**DANE COUNTY DEPT. OF
PUBLIC WORKS, HIGHWAY &
TRANSPORTATION**

ADDENDUM

RFB NO. 317035 - ADDENDUM NO. 1

COLISEUM PERFORMANCE AREA LIGHTING & RIGGING UPGRADES

EXHIBIT 1

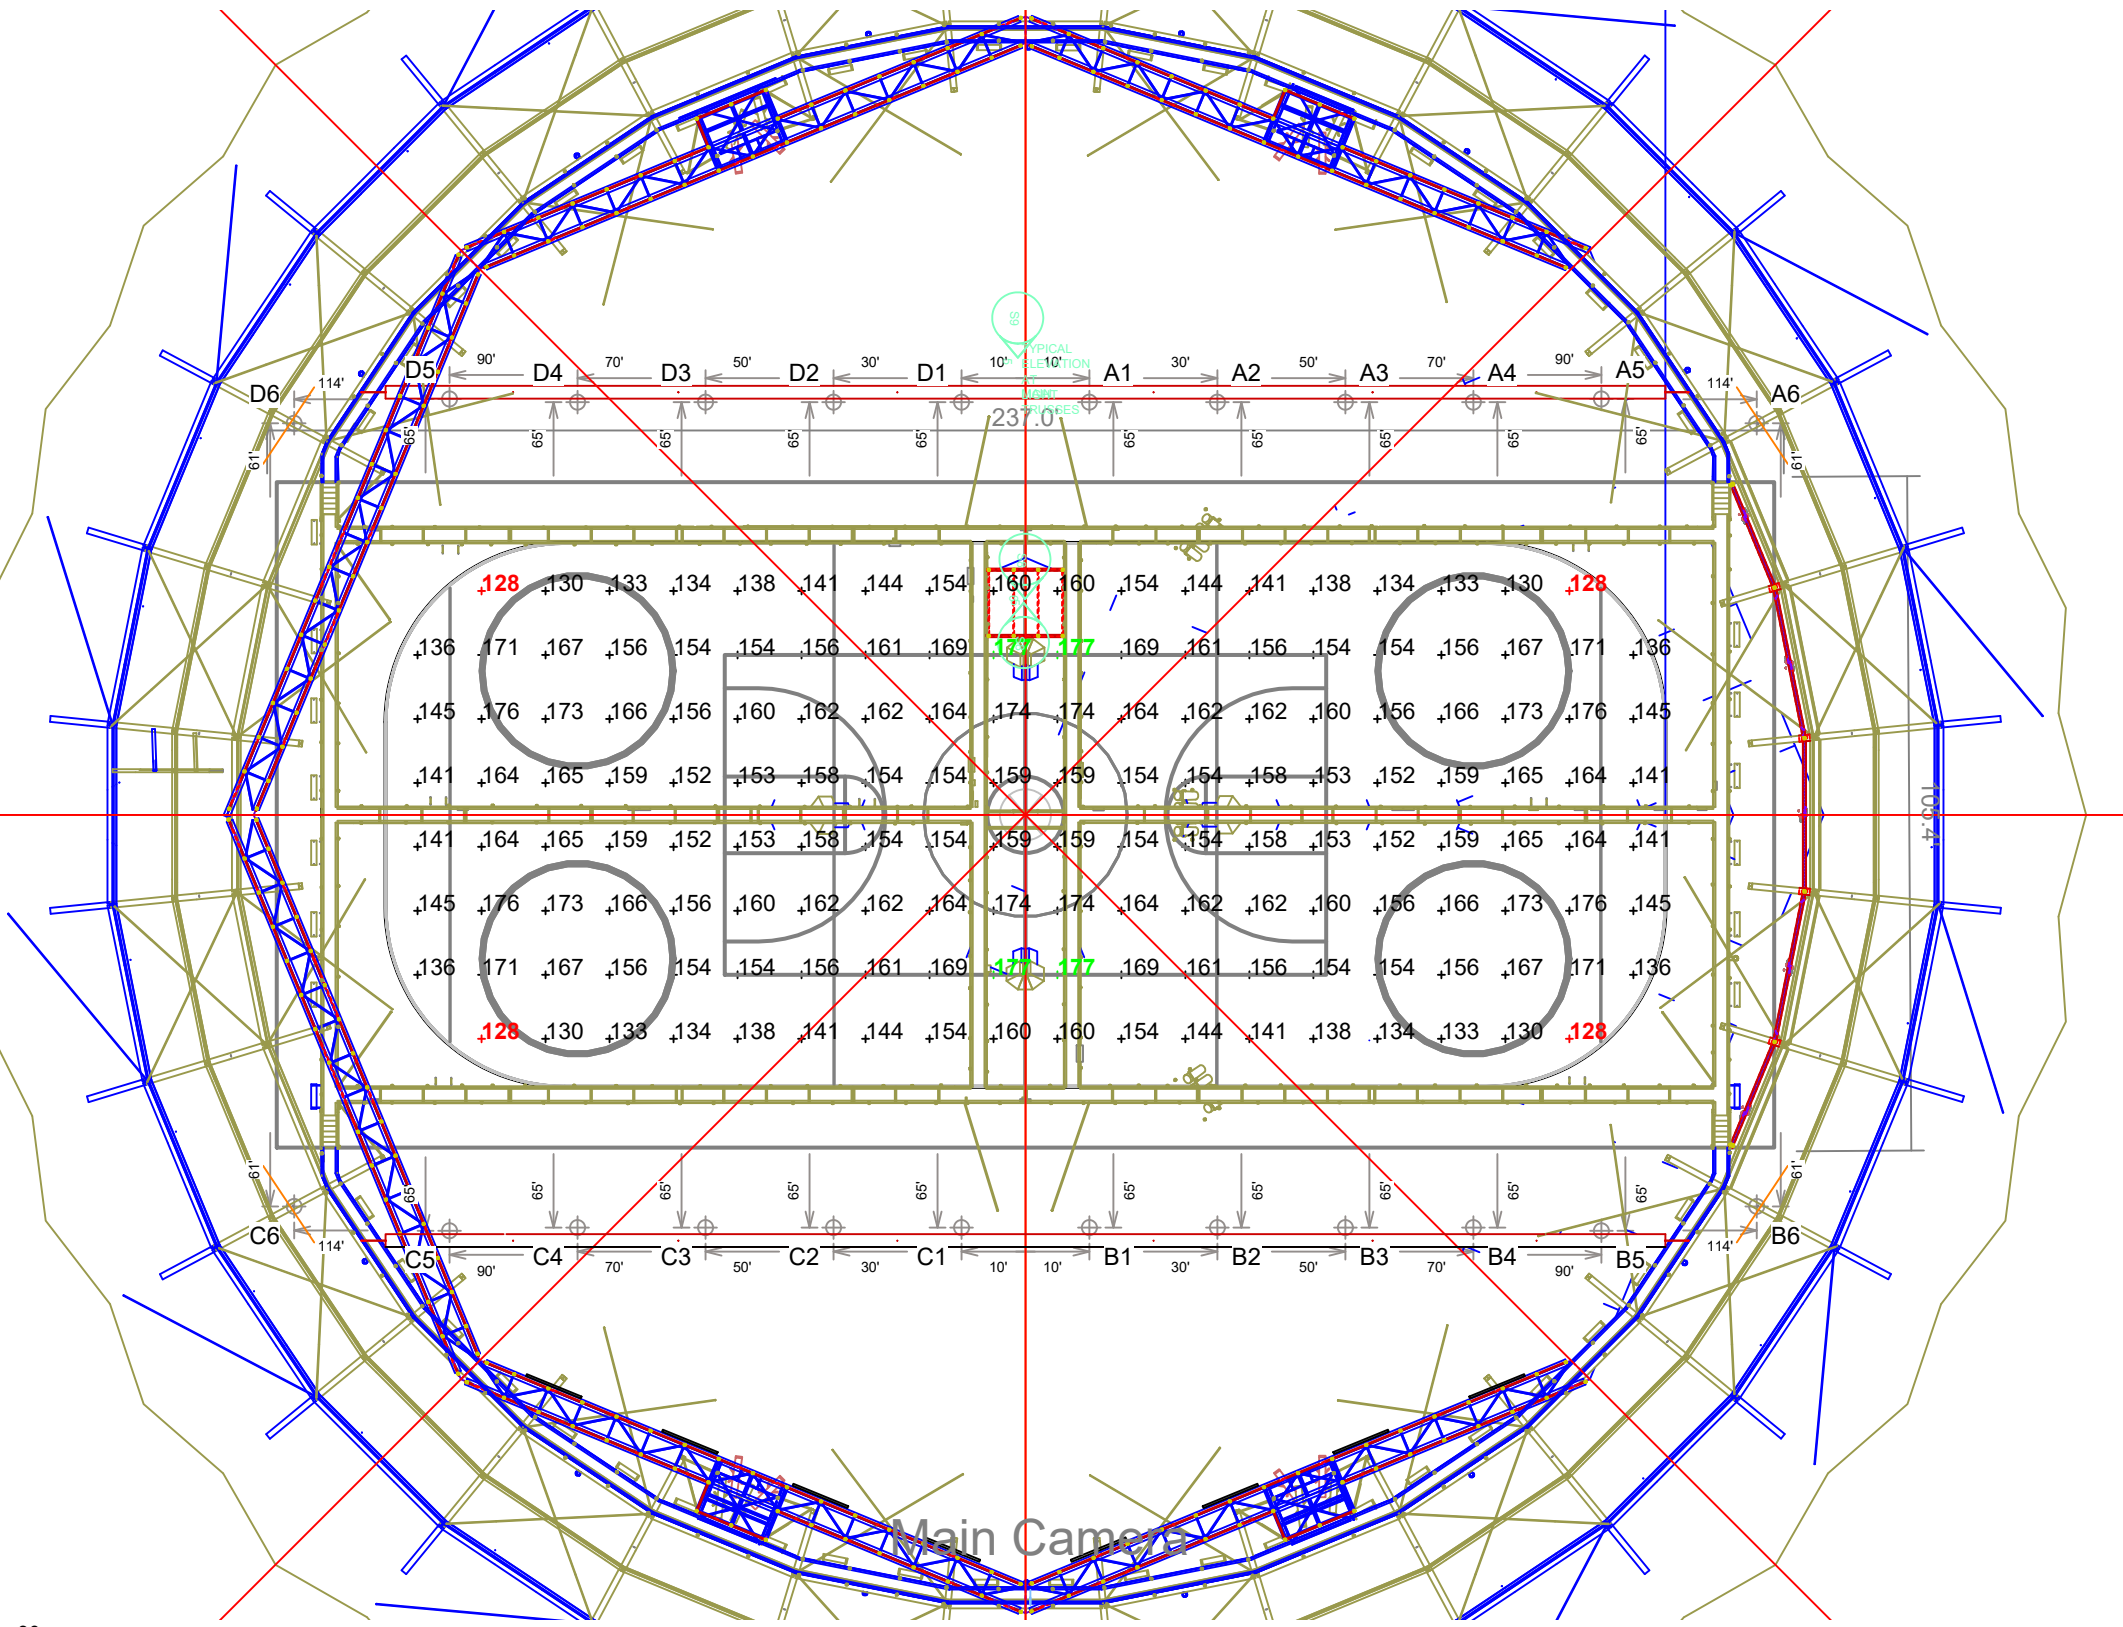
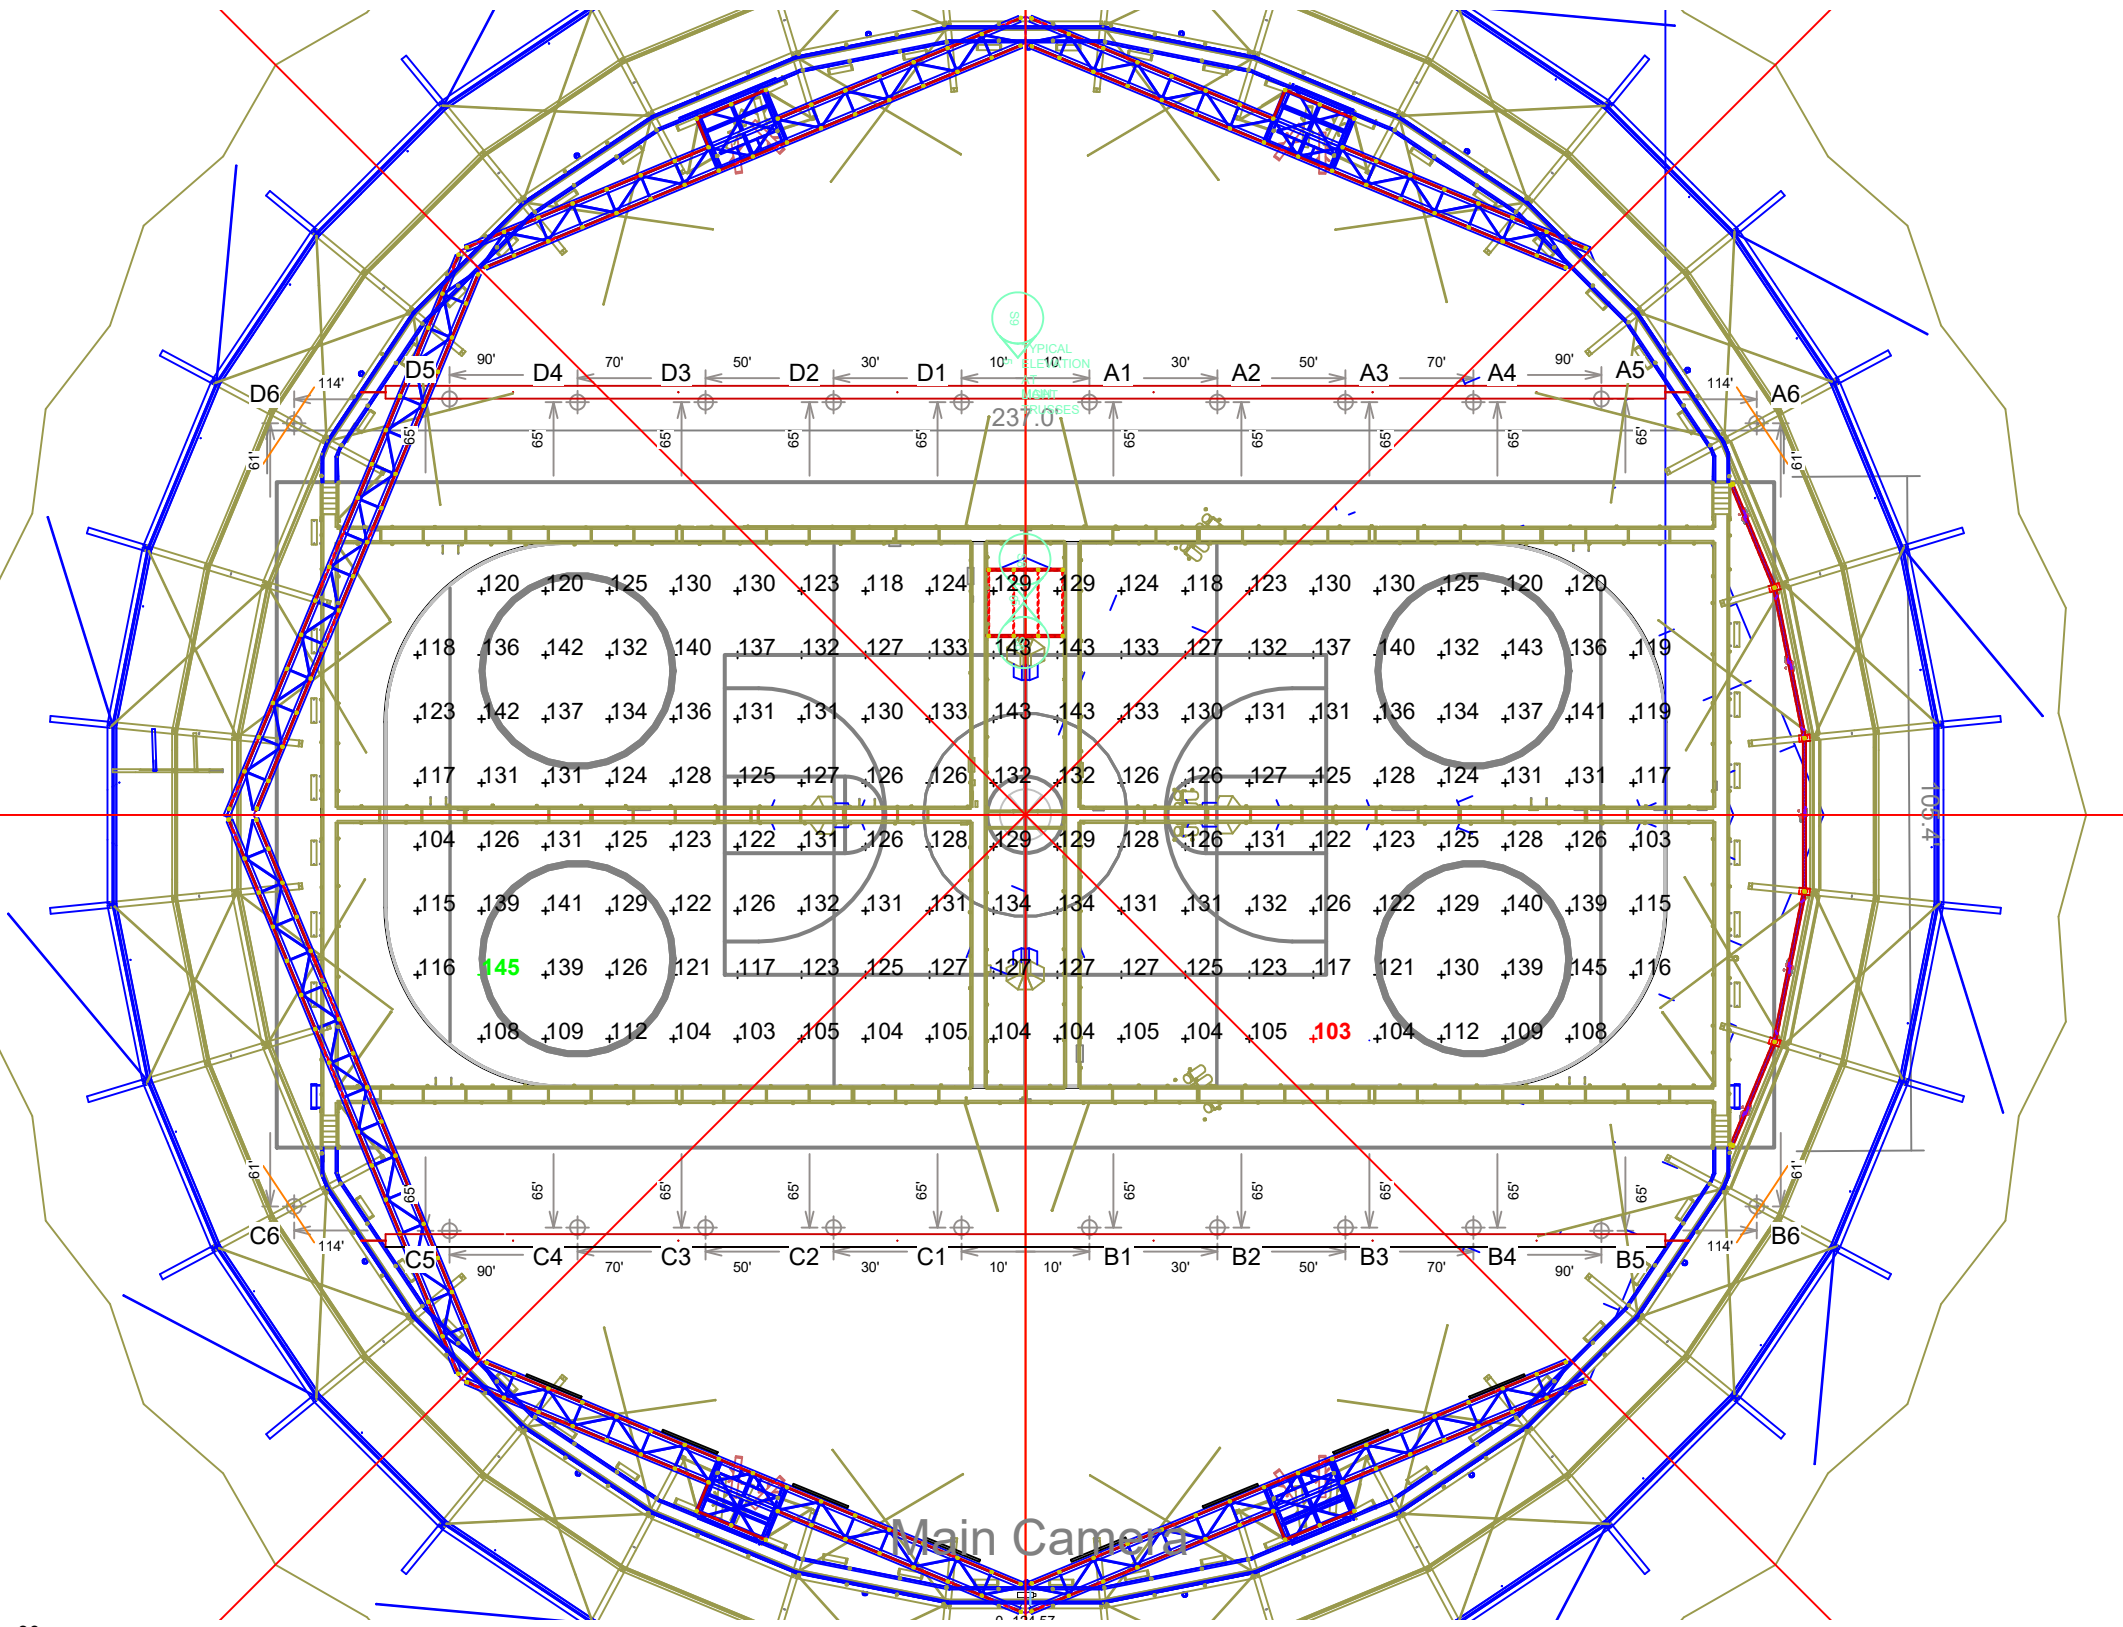
Delete current Exhibit 1; replace with new Exhibit 1, issued with this Addendum.
